Re: Draft EIS, Wyoming Windplant No. 1

APPENDIX H:
**OVERLAY OF PROPOSED PHASE I WINDPLANT FACILITIES LOCATIONS
FOR USE WITH FIGURES 3.14 THROUGH 3.17 IN THE FEIS**

Figure 1 Geologic Map of Project Area.

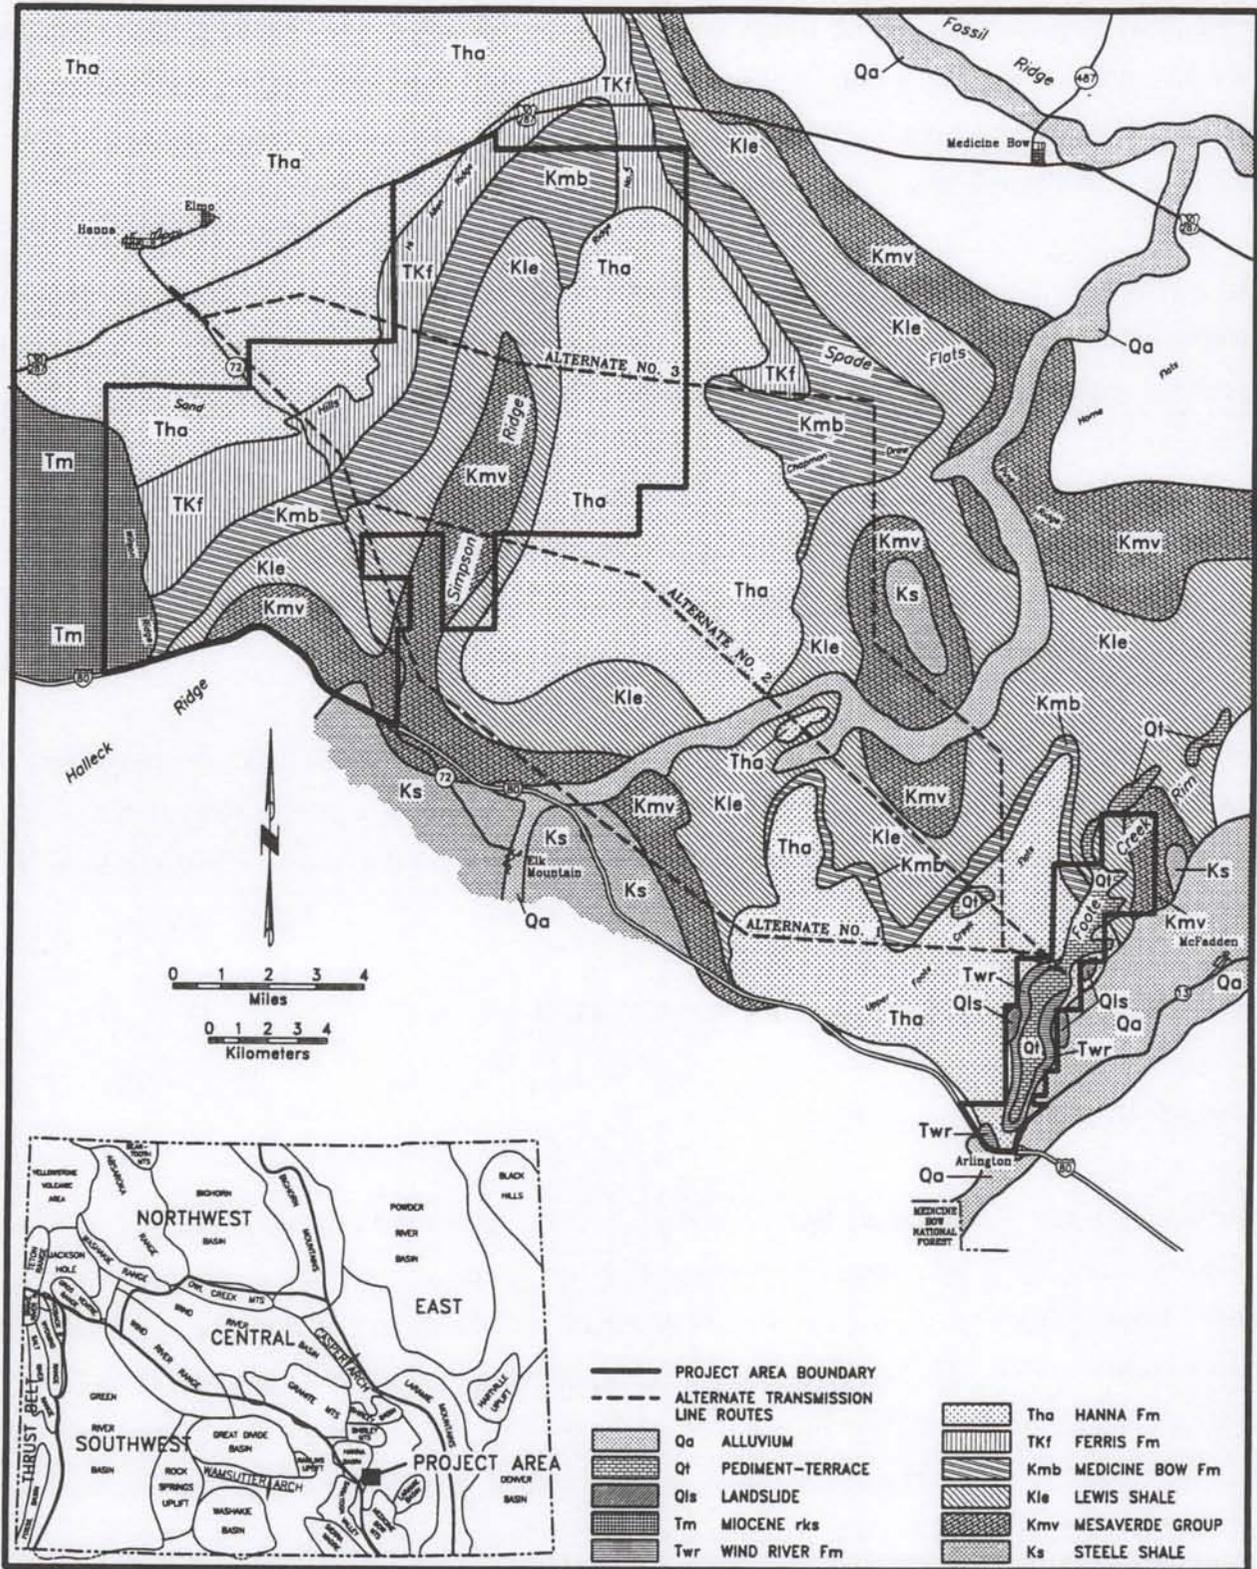
Geologic mapping (Dobbin et al. 1929, Lowry et al. 1973, Love and Christiansen 1985, Love et al. 1993) shown in Figure 1 documents the presence of at least 10 different geologic deposits in the project area. These include, from youngest to oldest: (1) unnamed deposits of late Holocene age, including unconsolidated eolian sands, stream gravels, alluvium, colluvium, and landslide material; (2) unnamed older alluvial and terrace deposits of late Holocene to possibly late Pleistocene age; (3) Browns Park Formation of middle Miocene age; (4) Wind River Formation of early Eocene age; (5) Hanna Formation of Paleocene age; (6) Ferris Formation of Late Cretaceous to Paleocene age; (7) Medicine Bow Formation of late Cretaceous age; (8) Lewis Shale of Late Cretaceous age; (9) Mesaverde Group of Late Cretaceous age; and (10) Steele Shale of Late Cretaceous age.
